From: South East Planning <southeastplanning@cyfoethnaturiolcymru.gov.uk>
Sent: 25 January 2024 14:25
To: Thomas Boothroyd; Planning DC
Subject: P/22/0206 - Vaynor Quarry (Major) V2 - NRW Response NRW:01140459
Attachments: P.22.0206 - Methry vaynor quarry v2.pdf; Abstraction licence response letter.pdf

BWRIAD / PROPOSAL: FIRST PERIODIC REVIEW OF OLD MINERALS PERMISSION (ROMP) AT VAYNOR QUARRY (PURSUANT TO ENVIRONMENT ACT 1995).

LLEOLIAD/LOCATION: VAYNOR QUARRY, UPPER VAYNOR ROAD, CEFN COED, MERTHYR TYDFIL, CF48 2LA.

Application to vary abstraction licence WA/057/0021/0014 Vaynor Quarry

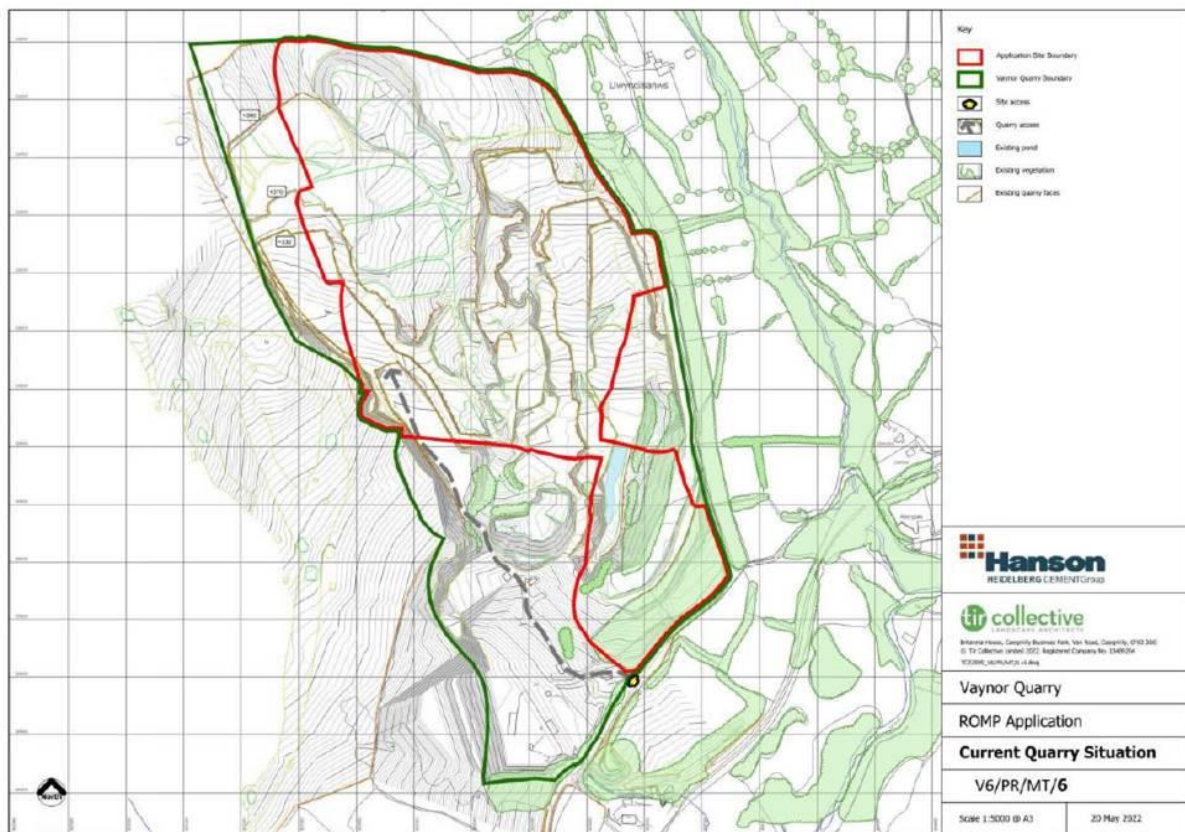
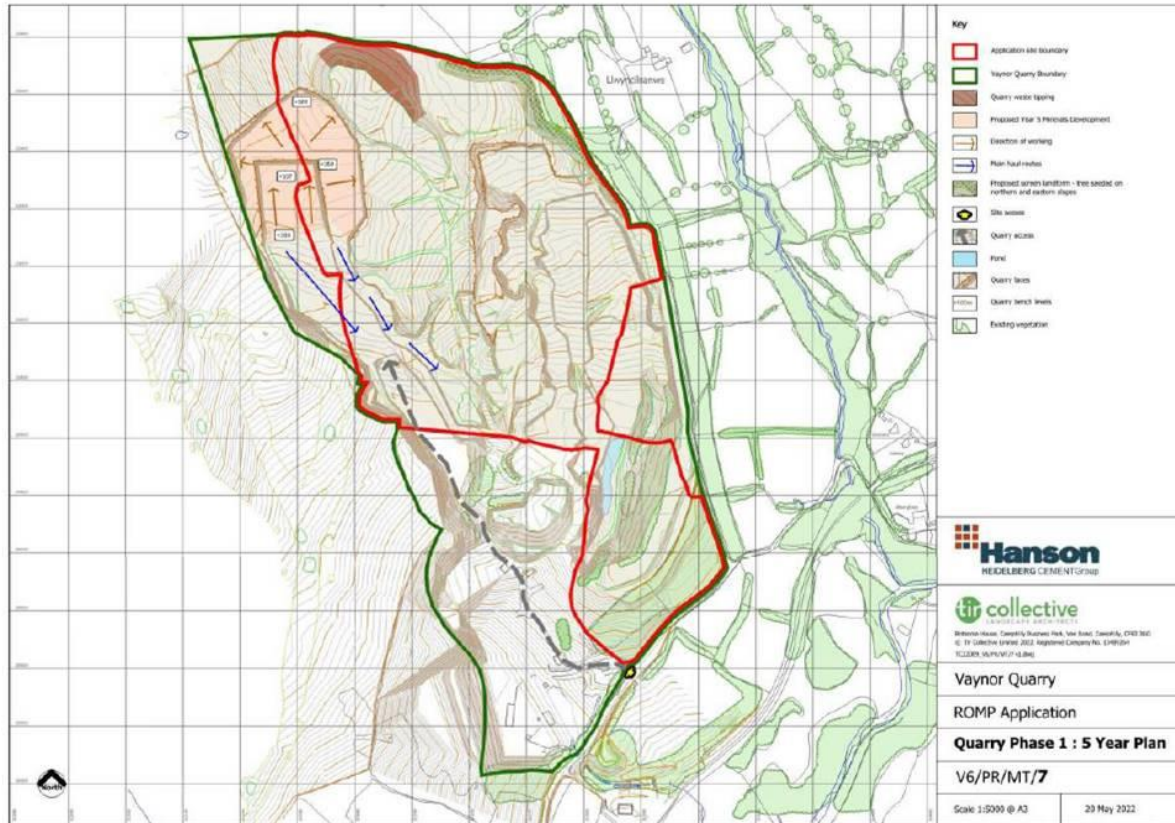
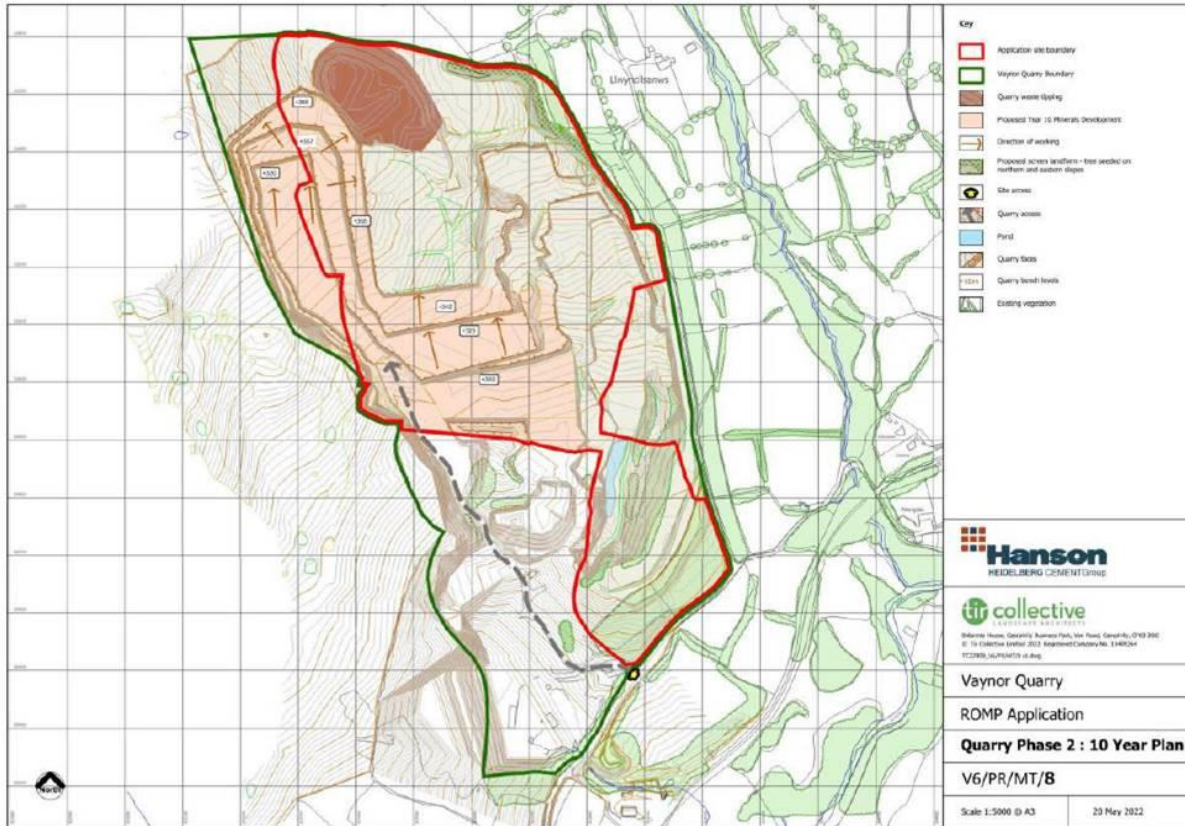
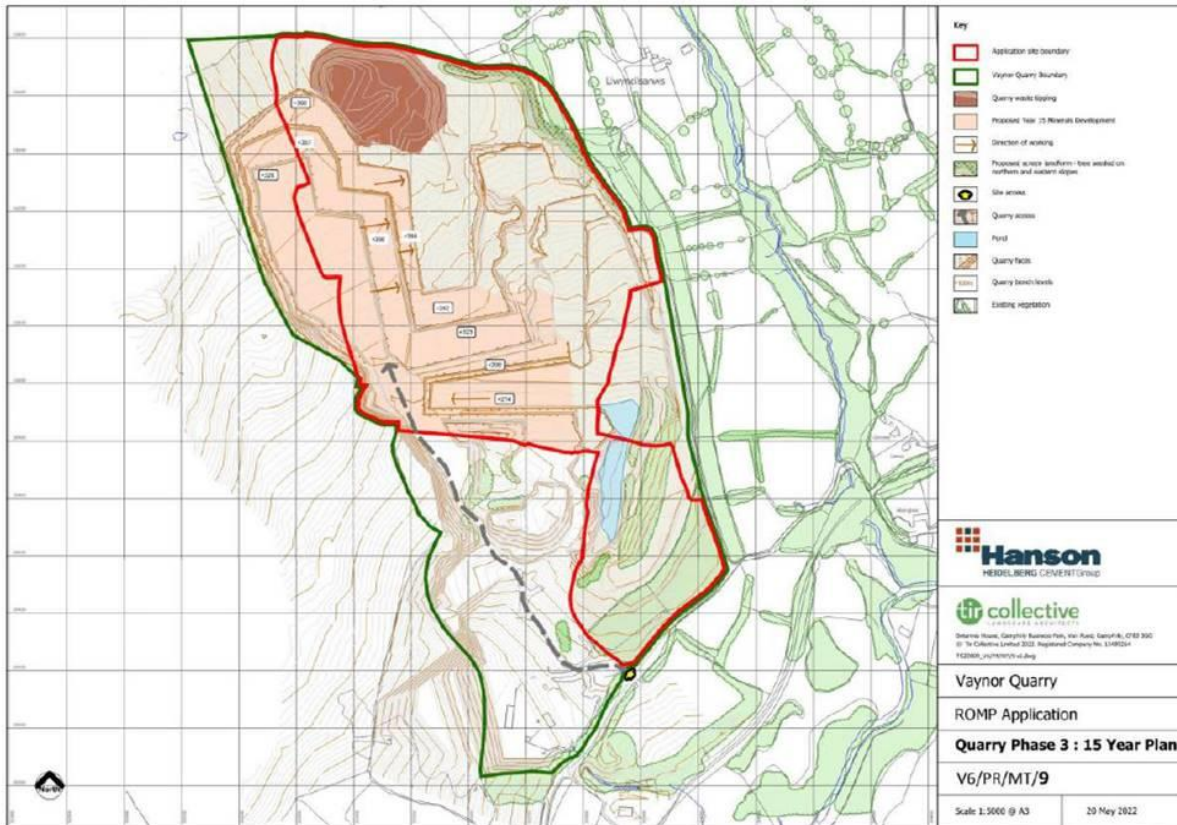
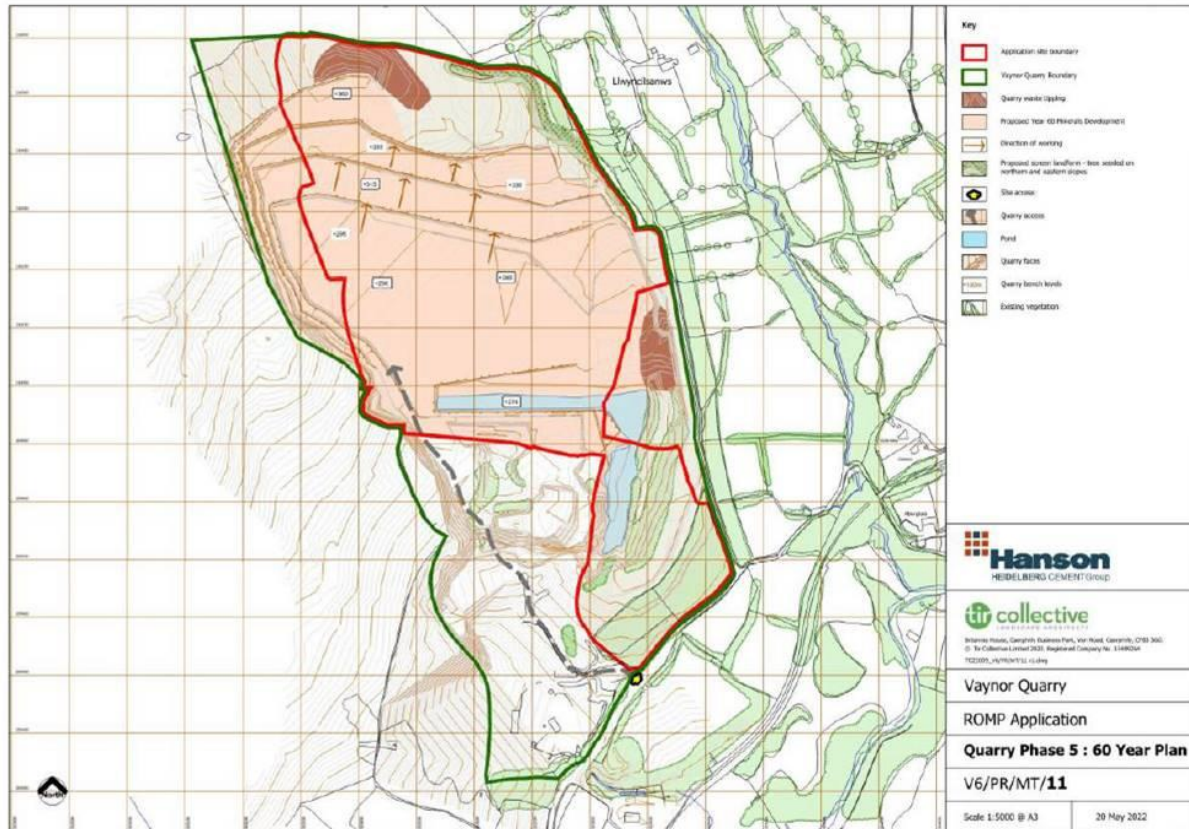
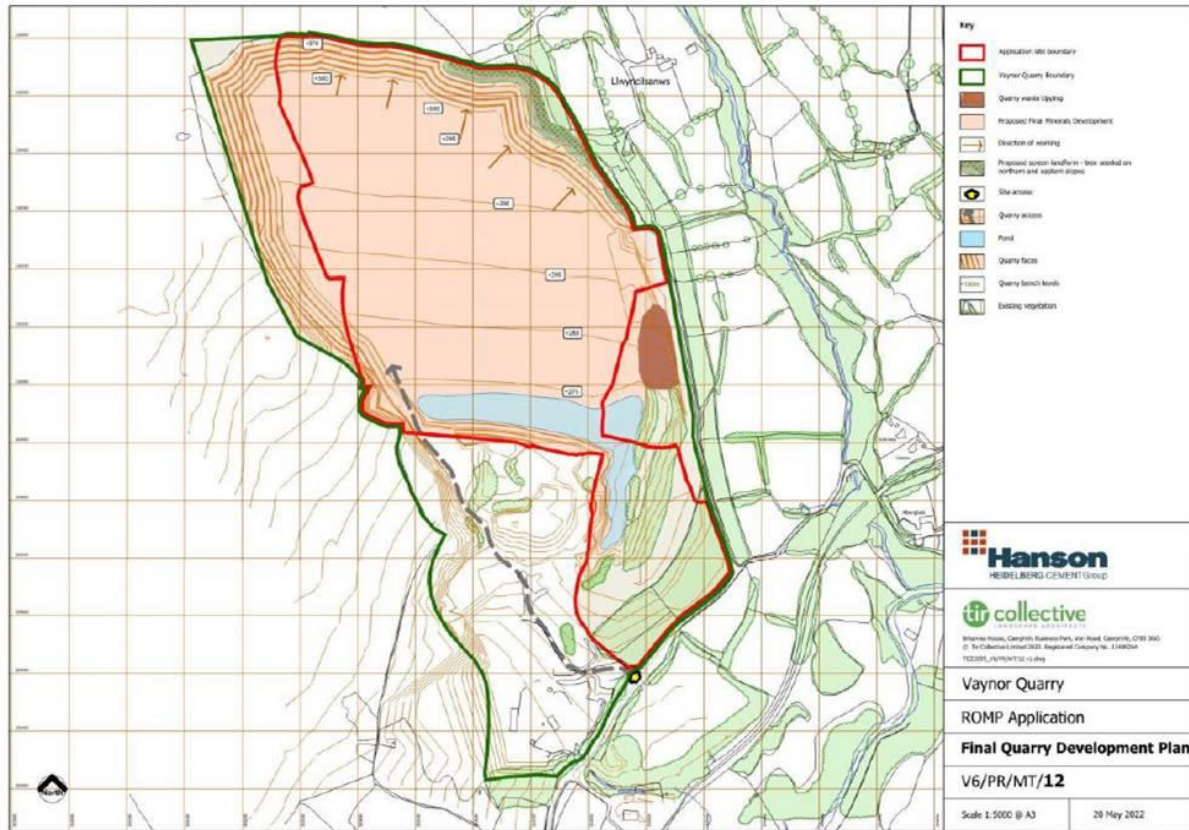
- The numeric model has simulated the SE pond as constant heads. Changes in the spatial characteristics of the pond over time have not been considered.

A review of the proposed phased quarrying excavation is presented in the **ES** as Figures 3-1 to 3-7 inclusive. These Figures show the current pond (light blue feature) within the SE portion of the site generally oriented North-South. After 15 years the pond is depicted as being slightly larger on the northern end of the pond

and then after 30 years a West-East oriented limb to the pond is shown as added which is then widened as part of the restoration phase.

- Simulate the pond in the SE corner of the site so that the simulations reflect changes in the spatial characteristics of the pond over time as the current model relies on one pond footprint. Explore calibration to pond levels.

2.13 Predicted heads in vicinity of Site in Layer 2: hydraulic conductivity 0.15 m

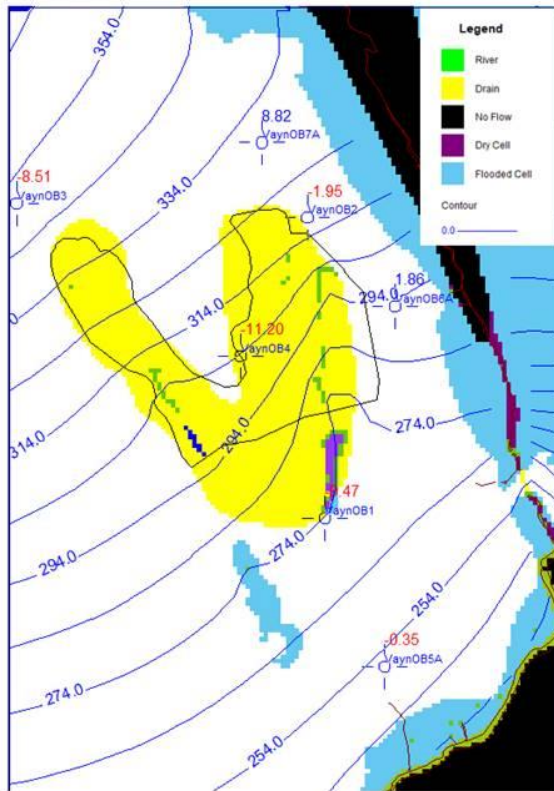
- The hydraulic conductivity values of 0.15m/d and 0.25m/d are not considered representative of fractured limestone. Hydraulic conductivity values representative of limestone fracture systems are generally significantly greater than the values used in the model.

- There are dry cells and flooding cells that have manifested during the numeric modelling exercise which indicate that the model is not a good representation of reality. These manifestations will interfere with model convergence. The model has a central 10 m grid and 5 layers and it does not appear to be representing site conditions very well. This is not surprising given the difficulty of modelling a fractured bedrock system with multiple sinks (springs / rivers) and topography and using inter-granular flow as the flow mechanism.

The following two figures shows the predicted heads using a hydraulic conductivity of 0.15m/d and 0.25m/d respectively. Calibration values to measured groundwater levels at particular wells, for example VaynOB3 to the west, are shown as either a simulated head increase in red or a head decrease in blue. For example, VaynOB5a located to the south shows a simulated head increase of - 8.35m using a hydraulic conductivity of 0.15m/day with a head decrease of +7.00m using a hydraulic conductivity of 0.25m/day. This shows that a simple change to the mass hydraulic conductivity value results in a significant difference in the simulated head values at VaynOB5a compared to actual values. Calibration has therefore not been achieved. Note that groundwater monitoring well VaynOB5a is the closest to the Taf Fechan ecosystem and springs.

- Revisit the nature of the numeric modelling that has been performed to date with an emphasis on assessing future flows and groundwater dynamics using a simulator that can model fracture-flow. This can only be considered successful if a meaningfully calibrated model for current conditions can be developed so that there is more confidence in predicted conditions and hydrodynamics. Calibration should utilise spring, river flow and pond level data. Explore integrating aspects of the FCA such as pond recharge and changes in the pond footprint that are proposed over the coming decades into the numeric groundwater model. Explore whether the pond groundwater system is best simulated using variable recharge or constant heads.

Figure 3.6 Additional drawdown imposed by proposed quarry extension in Layer 2:
hydraulic conductivity 0.15 m/d

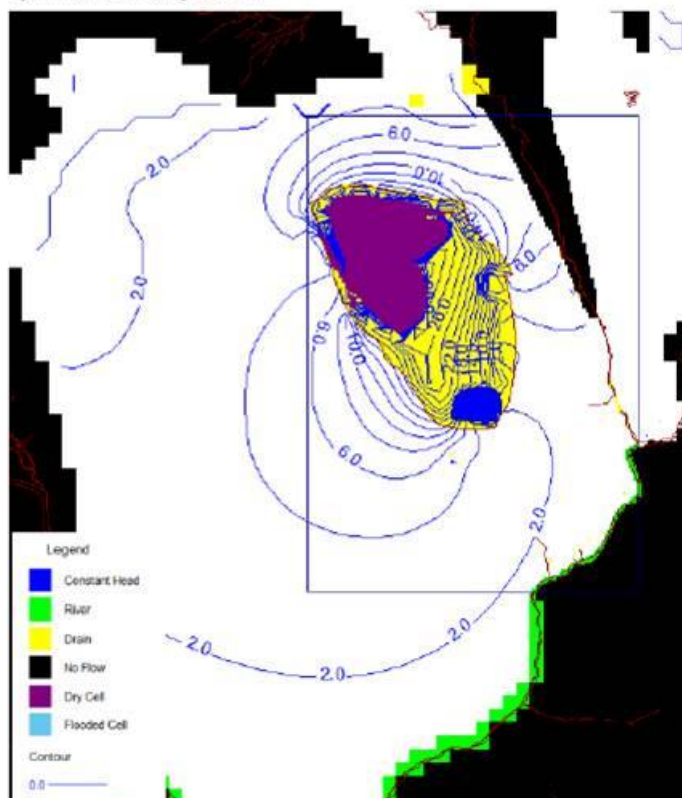
The following two figures shows the additional drawdown using a hydraulic conductivity of 0.15m/d and 0.25m/d respectively. There is a significant difference in the magnitude of the estimated drawdown to the east and northeast. The large blue area within the southern area is the pond and this has been simulated as a constant head which therefore controls the nature of the simulated groundwater drawdown contours around it and within the southern area of the site. Contouring within fractured rock systems must be treated with caution as such contouring are representative of equipotential lines which may not be representative of fractured rock systems.

Figure 6.2 Runoff catchments – current

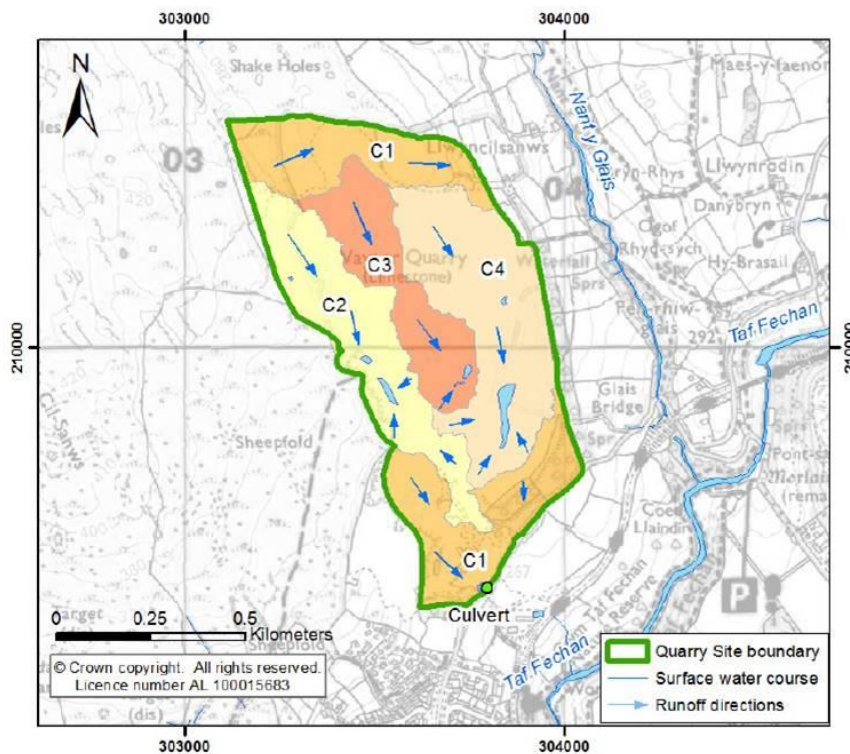
Page 37 of the **Vaynor Quarry: Flood Consequence Assessment (FCA) and Drainage Strategy, August 2022** depicts the current runoff catchments at the site. It is unclear if or how these were considered as part of the numeric groundwater modelling exercise.
